Access Compliance Report Public Rights-of-Way (Curb Ramps)

Main Street: **BROKEN_HILL_CT** Cross Street: **OLD_RANCH_RD** Location: **NE**

ADA ID: **RPAT210922085919** Ramp Type: **Type 3 - Combination 1** Initial Pass/Fail: **Fail** Overall Compliance: **No** Severity Score: **20**

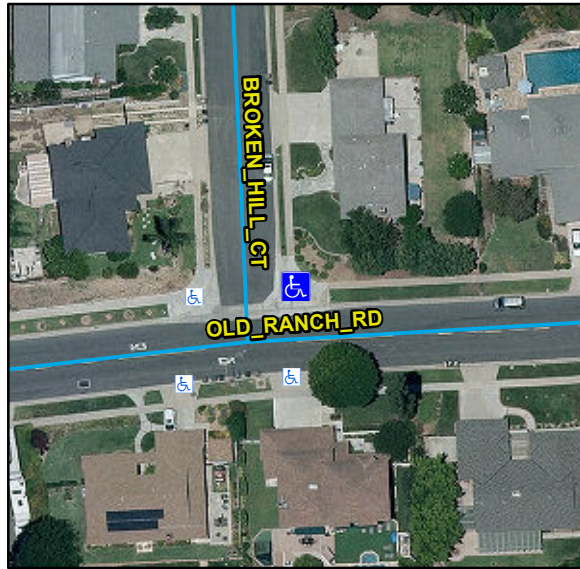
Compliance	Description	Data	Compliance	Description	Data
N/A	Ramp Length LT (in)	68	N/A	Ramp Length RT (in)	71
No	Ramp Width LT (in)	40	No	Ramp Width RT (in)	46
No	Ramp Run Slope LT (%)	11	Yes	Ramp Run Slope RT (%)	3.9
Yes	Ramp Cross Slope LT (%)	1.8	Yes	Ramp Cross Slope RT (%)	1.9
N/A	Ramp Length (in)	56	N/A	Flare Type LT	
Yes	Ramp Width (in)	48			N/A
No	Ramp Run Slope (%)	8.6	N/A	Flare Slope LT (%)	N/A
Yes	Ramp Cross Slope (%)	2.2	N/A	Flare Traversable LT	N/A
N/A	Landing Present	N/A	N/A	Flare Type RT	
N/A	Landing Length (in)	N/A			N/A
N/A	Landing Width (in)	N/A	N/A	Flare Slope RT (%)	N/A
N/A	Landing Run Slope (%)	N/A	N/A	Flare Traversable RT	N/A
N/A	Landing Cross Slope (%)	N/A	N/A	DWS Provided	N/A
N/A	Landing Movement Obstructed?	N/A	N/A	DWS Contrast	N/A
	Landing Movement Type	N/A	N/A	DWS Length (in)	N/A
N/A	Landing Shared	N/A	N/A	DWS Full Width	N/A
N/A	Clear Space	Yes		DWS Offset Type	N/A
N/A	Clear Space To Crosswalk (in)	N/A	N/A	DWS Offset Left (in)	N/A

Remove & Replace Curb Ramp With Two New Directional Ramps or Equivalent.
